ADDENDUM NO. 3 TO PROJECT NO. 44155-C, H, P, E

**REHABILITATE TOWER NOS. 5, 6 AND 7
CLINTON CORRECTIONAL FACILITY
ROUTE 374, COOK STREET
DANNEMORA, NY**

June 4, 2013

H1 SIDEWALK DETAIL (TYPICAL)
C-002 SCALE: 1 1/2" = 1'-0"

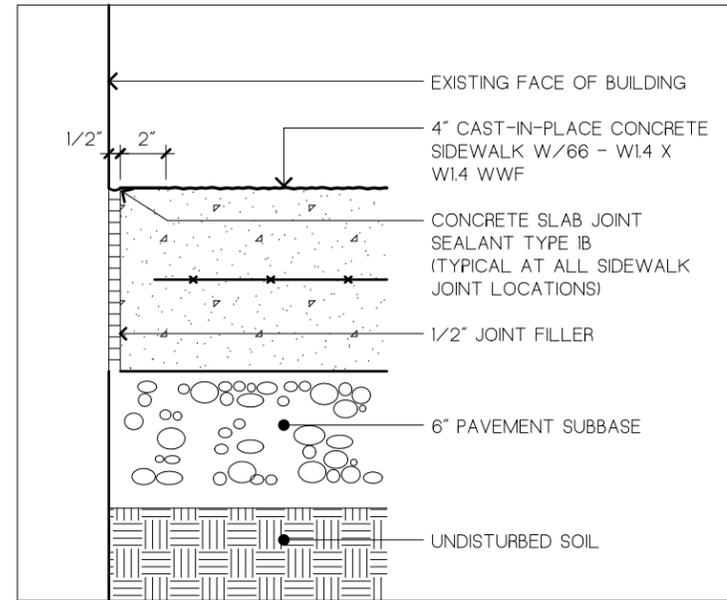
12. Drawing C-002:
 - a. REPLACE Detail H1/C-002 included in this Addendum and supersedes the same numbered originally issued drawing.
 - b. REPLACE Detail H3/C-002 included in this Addendum and supersedes the same numbered originally issued drawing.

K1 SIDEWALK EDGE DETAIL
C-002 SCALE: 1 1/2" = 1'-0"

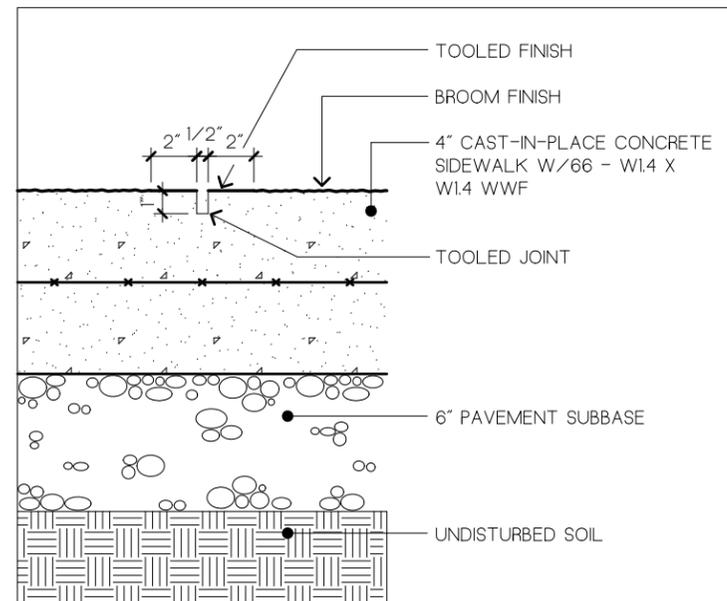
- c. REPLACE Detail K1/C-002 included in this Addendum and supersedes the same numbered originally issued drawing.
 - d. REPLACE Detail K3/C-002 included in this Addendum and supersedes the same numbered originally issued drawing.

K4 STAIR DETAIL AT GUARD POST #7
 C-002 SCALE: 1/2" = 1'-0"

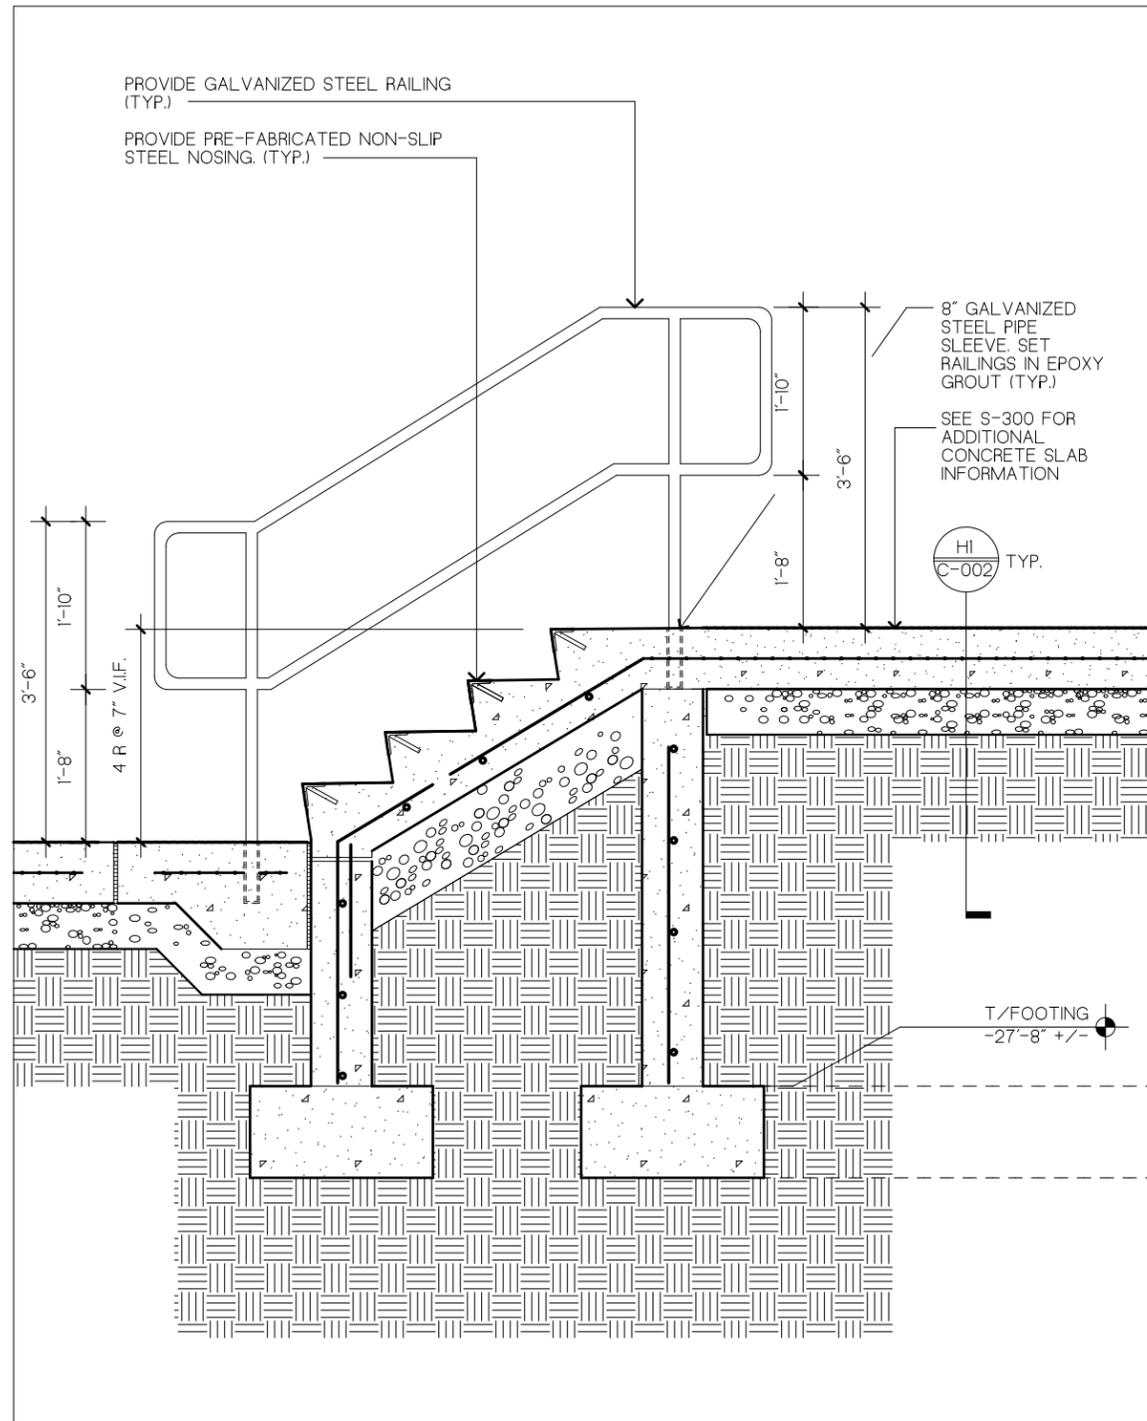
- e. REPLACE Detail K4/C-002 included in this Addendum and supersedes the same numbered originally issued drawing.
 - f. REPLACE Detail K10/C-002 included in this Addendum and supersedes the same numbered originally issued drawing.

F3
A-401

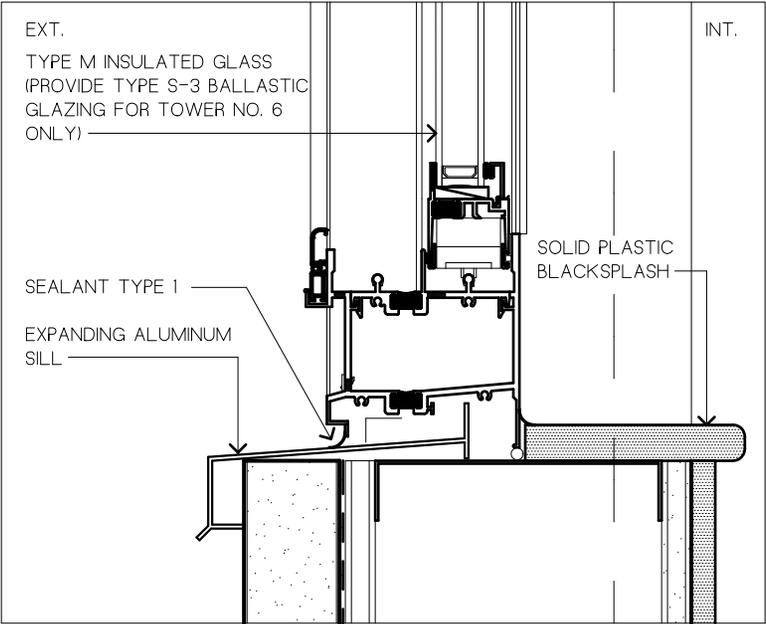
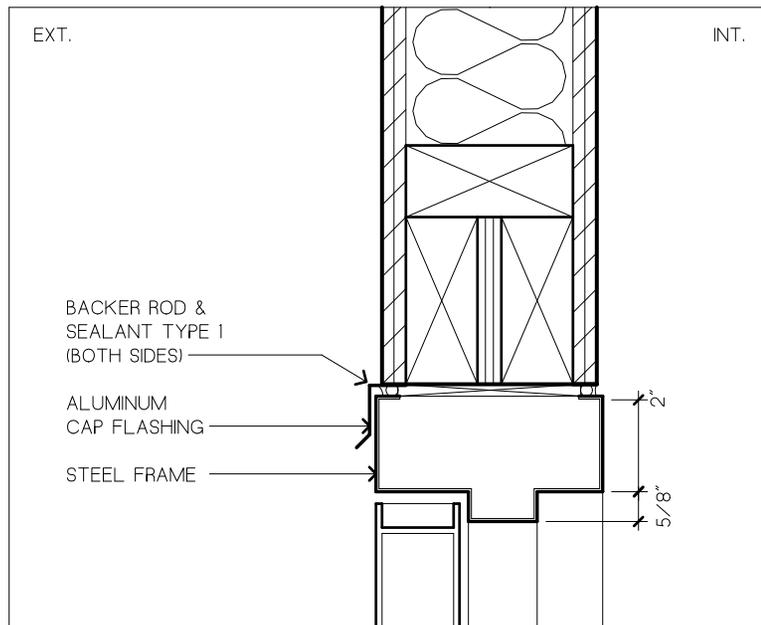
- b. REPLACE the Finish Schedule for Guard Post No. 100 with the included Finish Schedule in this Addendum.
 - c. REPLACE Detail F3/A-401 included in this Addendum and supersedes the same numbered originally issued drawing.

B5 STEEL FRAME HEAD DETAIL
 A-401 SCALE: 3" = 1'-0"

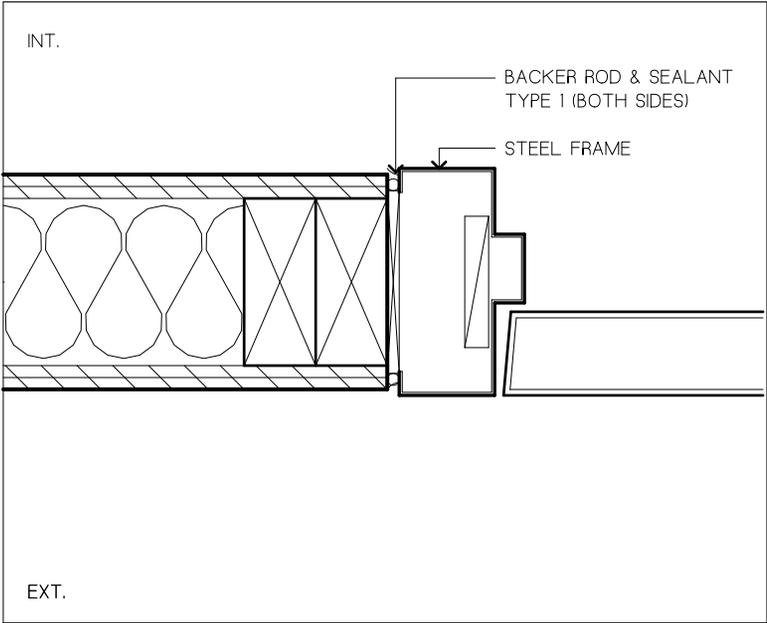
- d. REPLACE Detail B5/A-401 included in this Addendum and supersedes the same numbered originally issued drawing.
 - e. REPLACE Detail D5/A-401 included in this Addendum and supersedes the same numbered originally issued drawing.

B7
 A-401

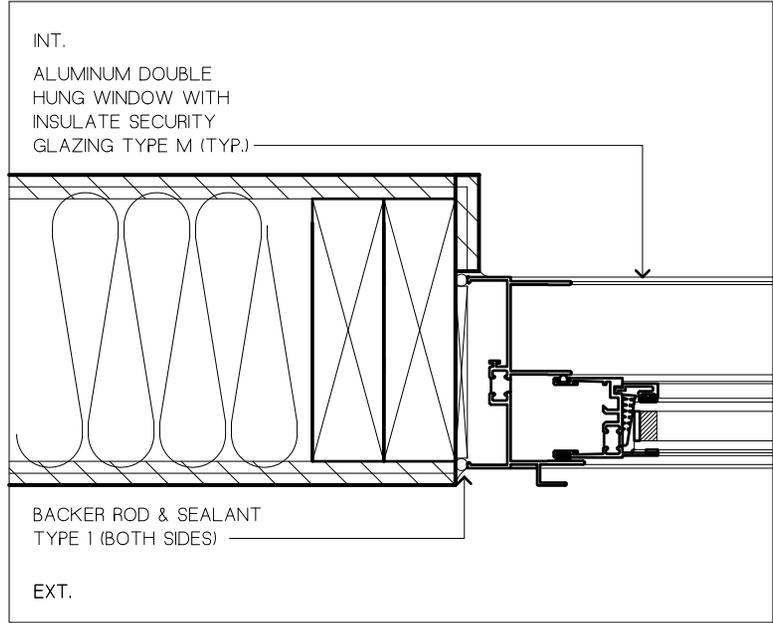
- f. REPLACE Detail B7/A-401 included in this Addendum and supersedes the same numbered originally issued drawing.
 - g. REPLACE Detail D7/A-401 included in this Addendum and supersedes the same numbered originally issued drawing.

H7 WINDOW SILL DETAIL
A-401 SCALE: 3" = 1'-0"

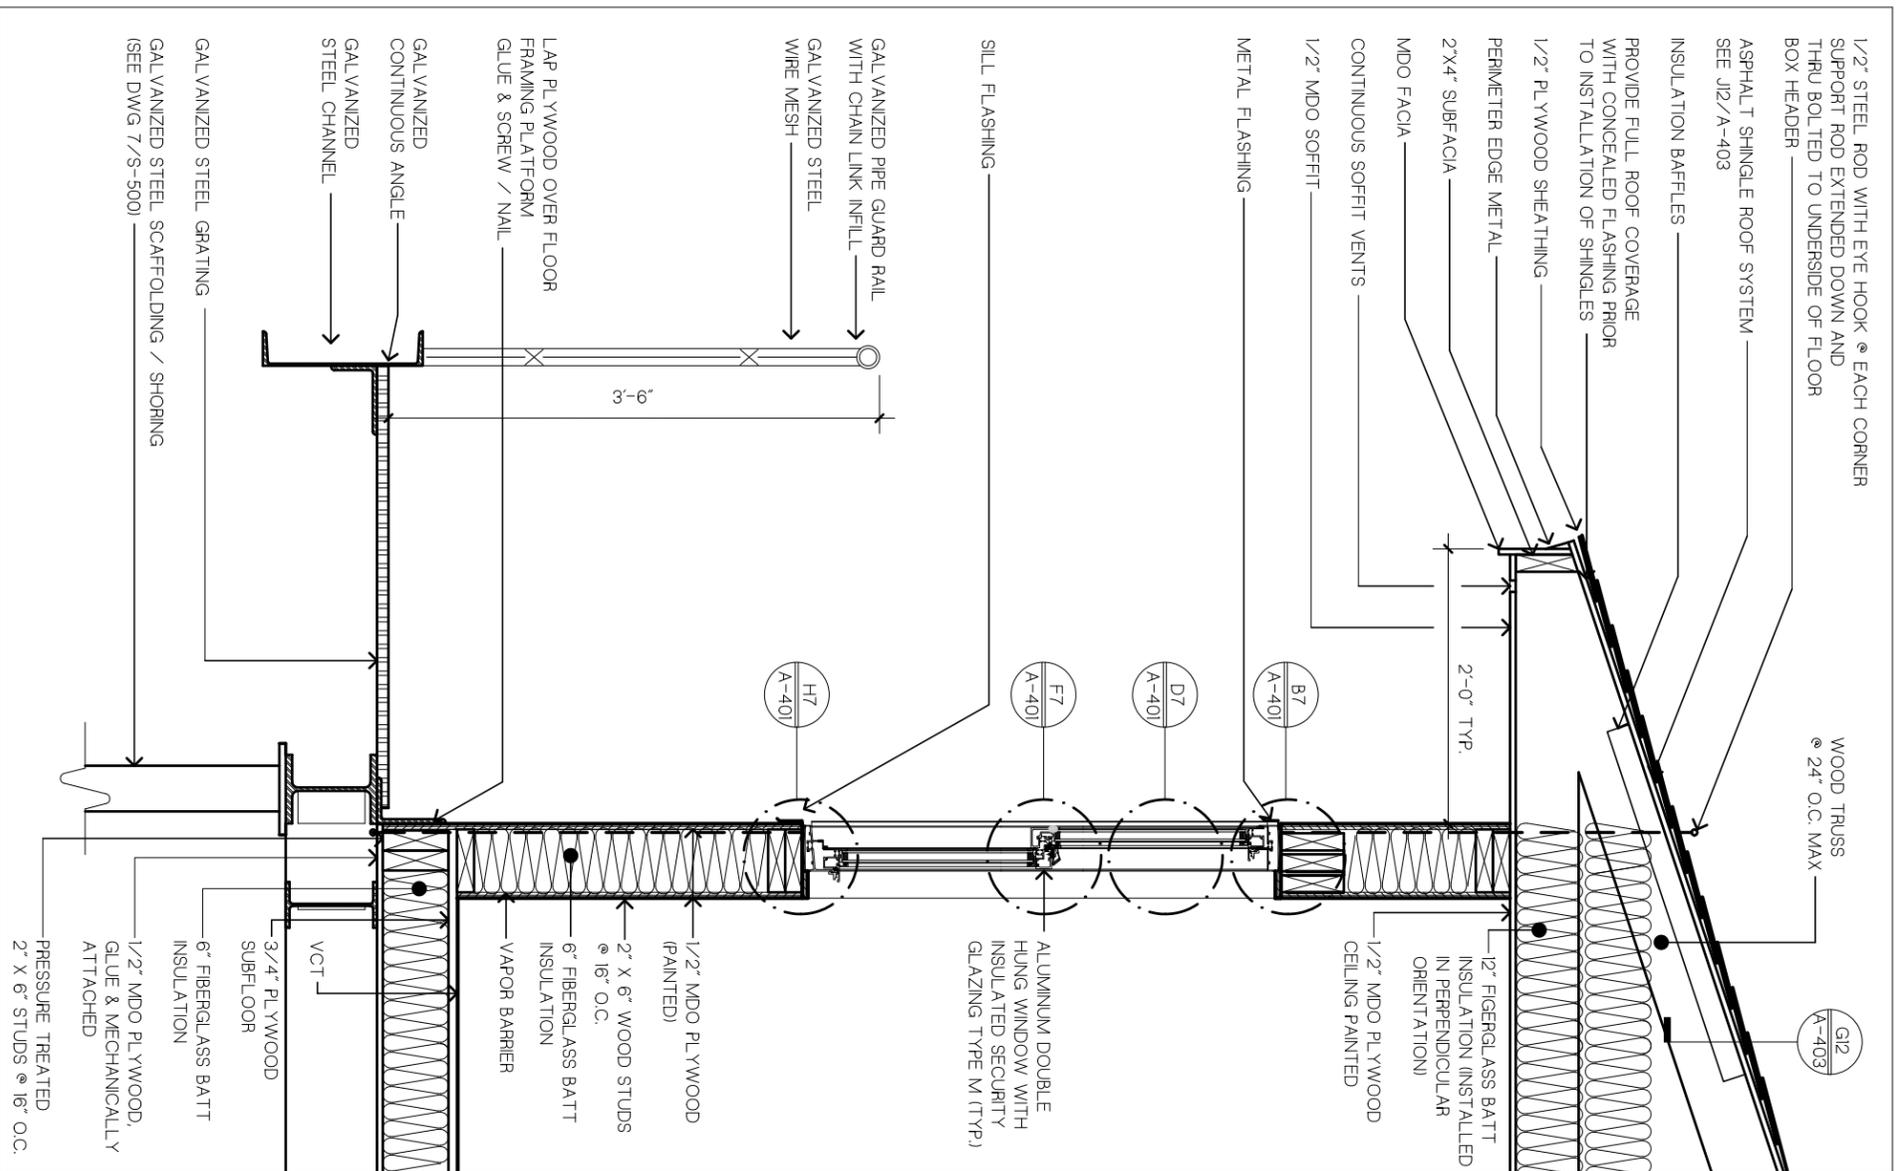
- h. REPLACE Detail H7/A-401 included in this Addendum and supersedes the same numbered originally issued drawing.
20. Drawing A-403:
- a. REPLACE Detail K9/A-403 included in this Addendum and supersedes the same numbered originally issued drawing.

K9
A-403
SCALE: 3/4" = 1'-0"

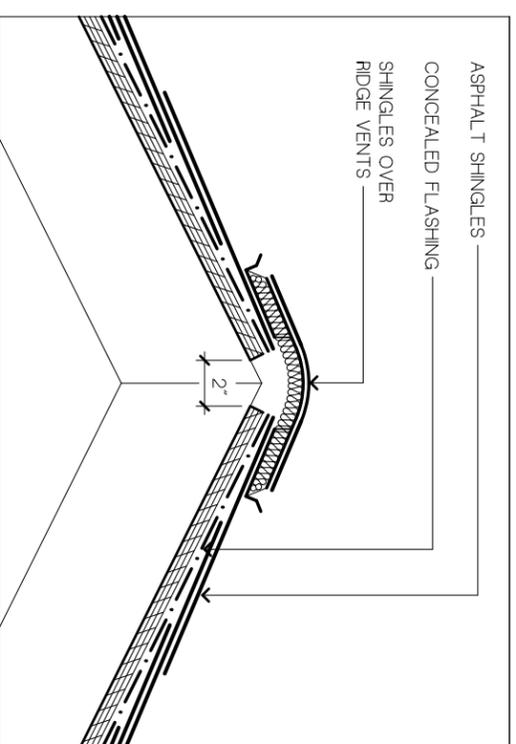
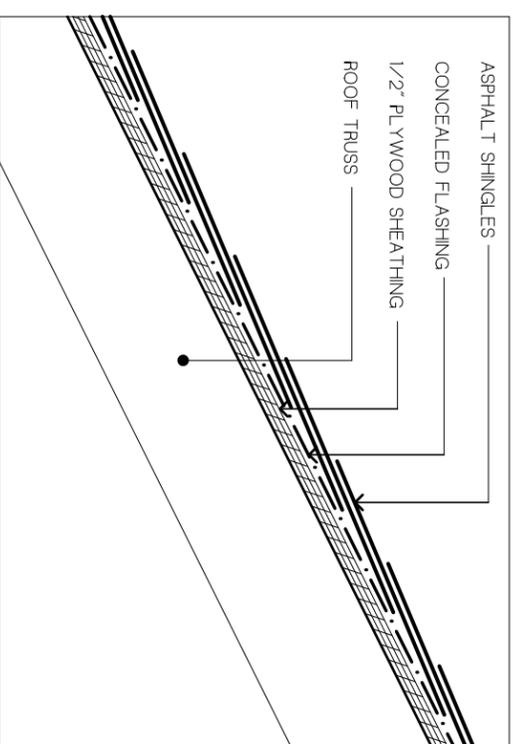
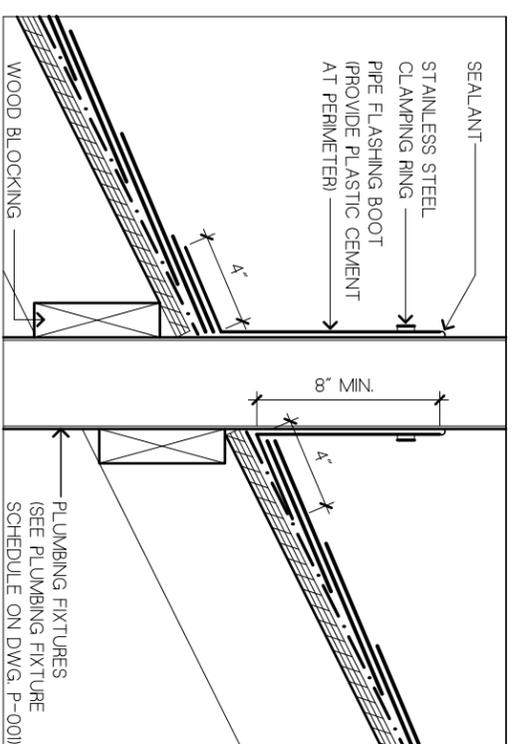
- b. REPLACE Detail G12/A-403 included in this Addendum and supersedes the same numbered originally issued drawing.
 - c. ADD Detail J12/A-403 included in this Addendum.

- d. ADD Detail K12/A-403 included in this Addendum.
21. Drawing P-001
- a. ADD the following to the Abbreviations on the Plumbing Legend:
EIT Electric Incinerating Toilet
